# CITY OF CONWAY, ARKANSAS HISTORIC DISTRICT COMMISSION

February 27, 2023 • 5:30pm • 1111 Main Street

A. 1516-1518 Caldwell Street - Window replacement (HDR-0822-310)

A. 565 Front Street - Adaptive Reuse (HDR-0123-0001)

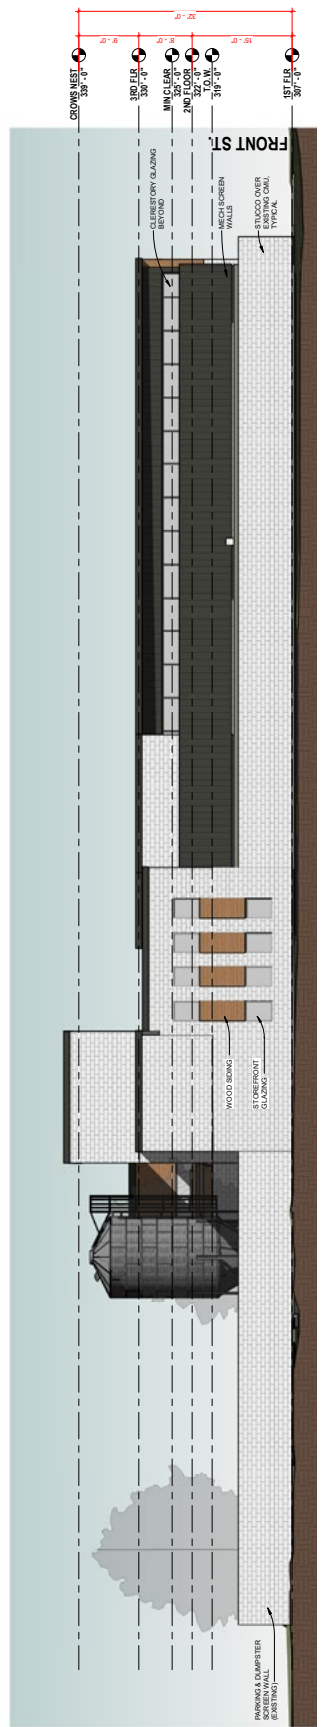
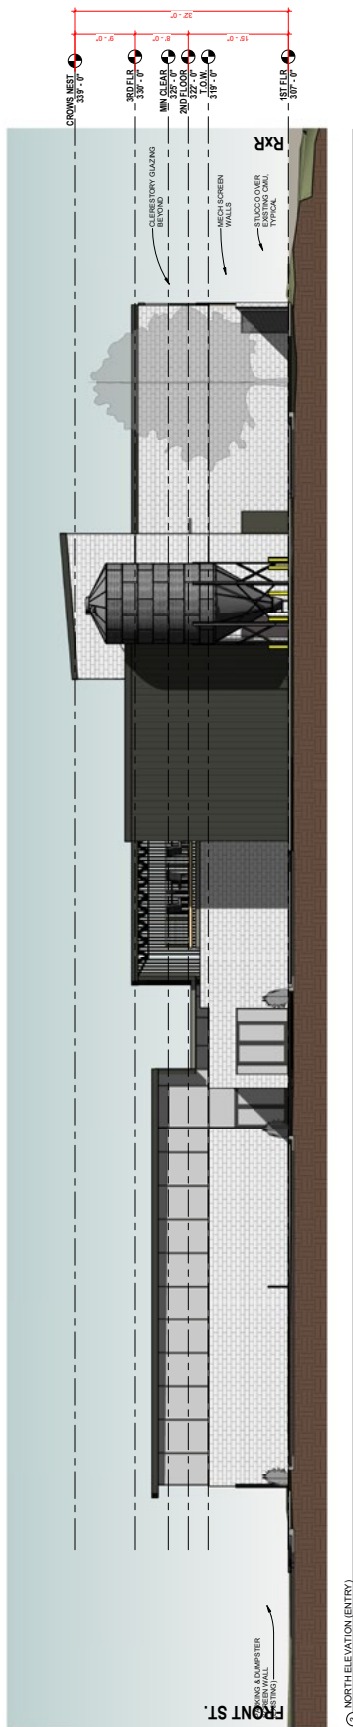
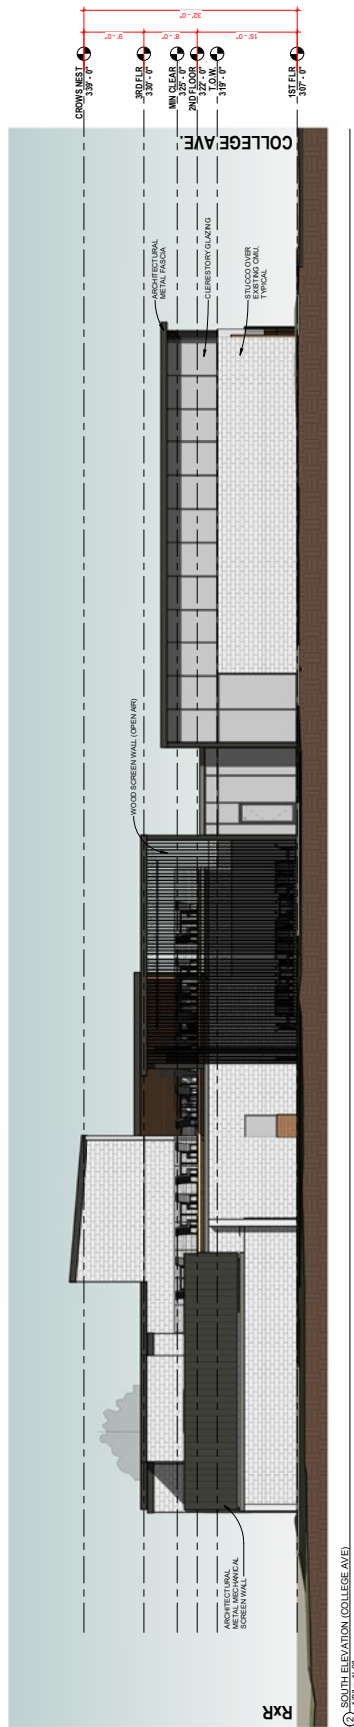
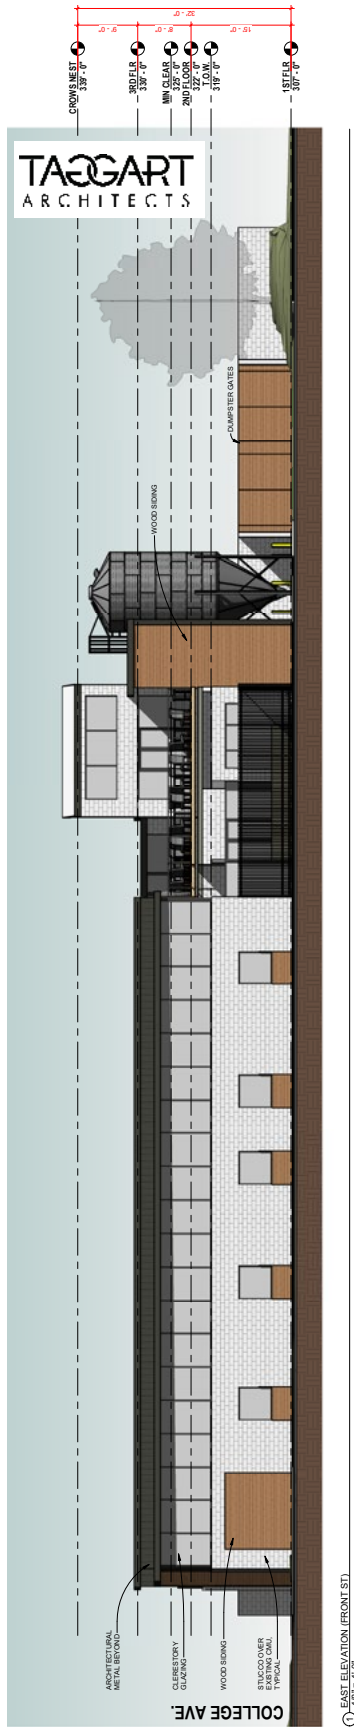
*The proposed façade articulation along Front St incorporates the appropriate amount of windows and strategies to achieve the desired articulation. The College Ave façade, and façades facing west and north incorporate fewer articulating elements and thus have a far more monolithic appearance. Recommend requiring additional windows at the east and west ends of the façades in both pickleball and office areas.*

*The Front St façade incorporates the appropriate amount of windows. The other façades offer limited ground level windows.*

- 1. additional first story windows at the east and west ends of the College Ave façade in both pickleball court and office areas;*
- 2. adding first story windows at the east end of the interior, north-facing façade, in the pickleball court area;*
- 3. adding second story windows at the west end of the interior, north-facing façade, in the private dining area (restrooms occupy this area on the first story);*
- 4. adding first story windows at the south end of the west-facing façade in the office area; and*
- 5. adding first story windows on west-facing façade in the catering area. If windows are feasible in the food preparation areas, façade articulation and detail must be achieved by another strategy.*

*Applicant shall confirm that proposed glazing meets transparency requirements. In addition to glass, the applicant is proposing to apply stucco over the existing concrete masonry unit (CMU). Material must be true a stucco material, not EIFS. Wood paneling and architectural metal accents along with an open-air wood screen wall are also proposed. The architectural metal and wood screen wall are appropriate in their proposed amounts. Wood paneling is prohibited; an alternative material shall be proposed by the applicant.*

4. Fencing proposed around outdoor pickleball court shall be 70% open.
5. Any material treatment applied to existing CMU must be true stucco; EIFS is not permitted on any first floor areas.

6. 85% of all first story glazing shall be transparent.
7. Additional first story windows are required at the east and west ends of the College Ave façade in both pickleball court and office areas.

8. Additional first story windows are required at the east end of the interior, north-facing façade, in the pickleball court area.
9. Additional second story windows are required at the west end of the interior, north-facing façade, in the private dining area.

10. Additional first story windows are required at the south end of the west-facing façade in the office area.
11. Additional first story windows are required on the west-facing façade in the catering area. If windows are feasible in the food preparation areas, façade articulation and detail must be achieved by another strategy and shall be approved by the Director of Planning.

12. The portions of the building proposed to be clad with wood siding shall be clad with an alternate material in with accordance building material requirements.

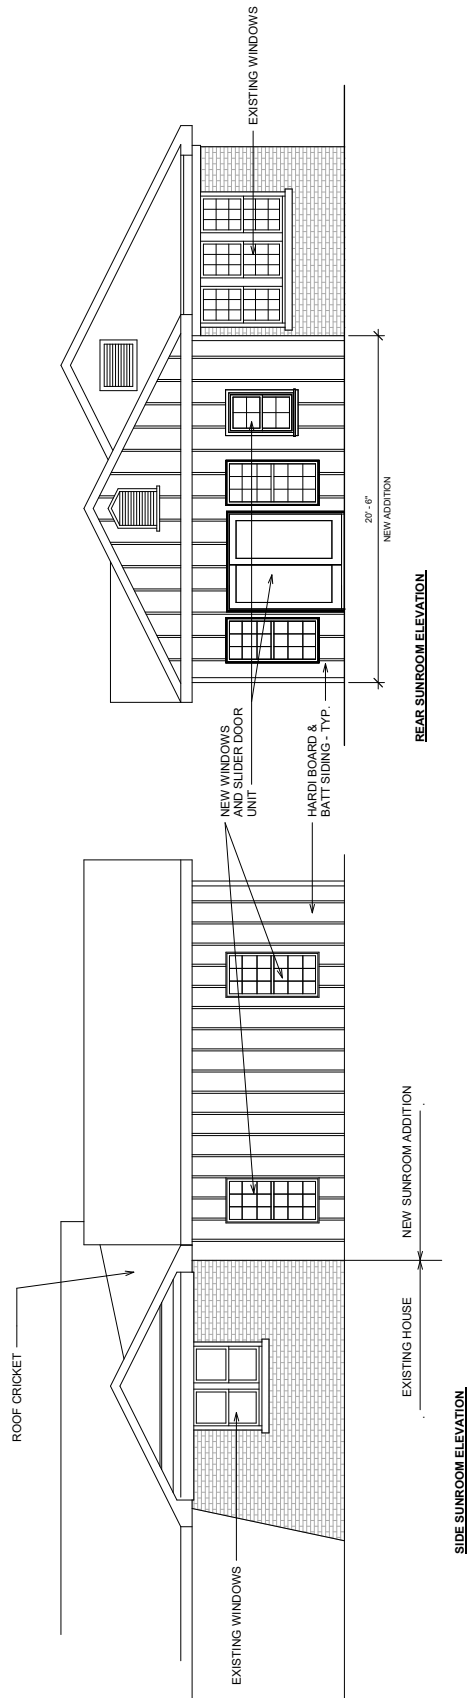
*The addition is located at the rear of the structure in an appropriate manner. The scale of the addition does not visually overpower the existing structure. The proposed cladding of Hardie® board and batten siding is substantially different from the brick of the existing structure, but is an acceptable historic material and is therefore appropriate.*

*Single-hung windows are proposed to match existing windows. Window type is appropriate, however fake muntin bars are prohibited. If muntin bars are proposed, they must be true divided lights.*

1. Windows shall match the style of the existing primary structure. If muntin bars are used they shall be true divided lights (fake muntin bars are prohibited).

NORTH ELEVATION  
SCALE: 1/8" = 1'-0"

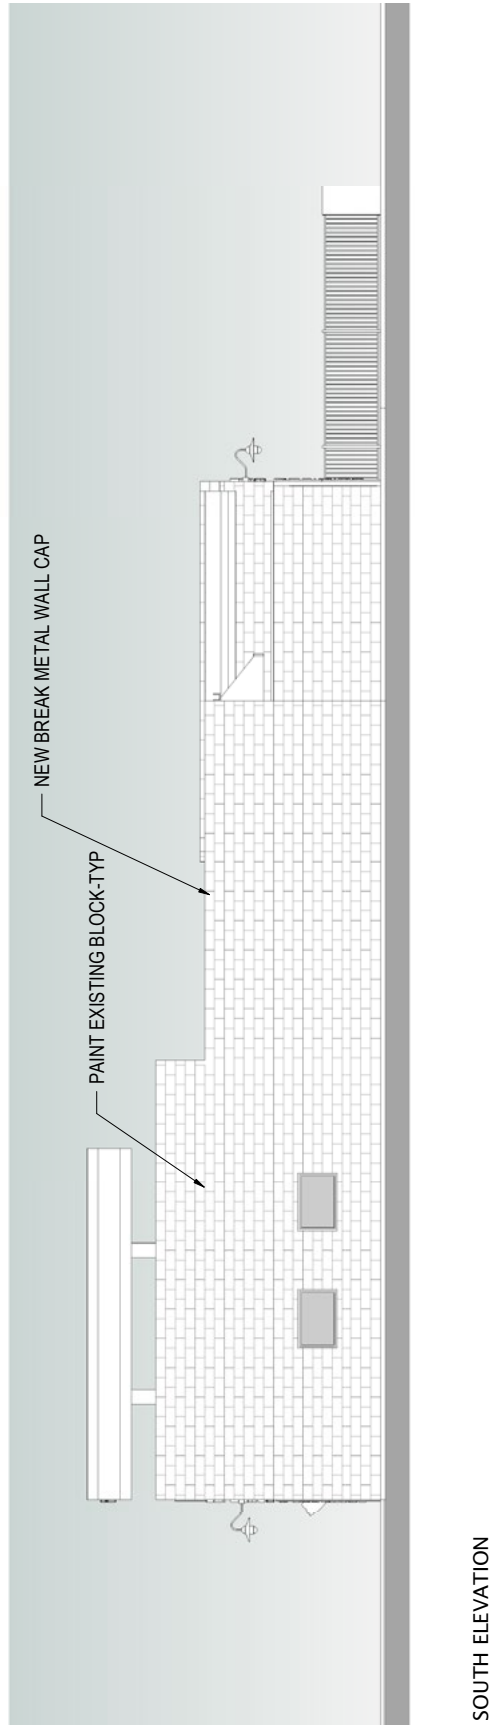
*The south elevation has a large flat unbroken façade that is wholly inappropriate to the area.*

4. South elevation will require articulation to prevent the appearance of flat, unbroken walls.
5. Sidewalks and curbing along Monroe St are required prior to issuance of a Certificate of Occupancy.
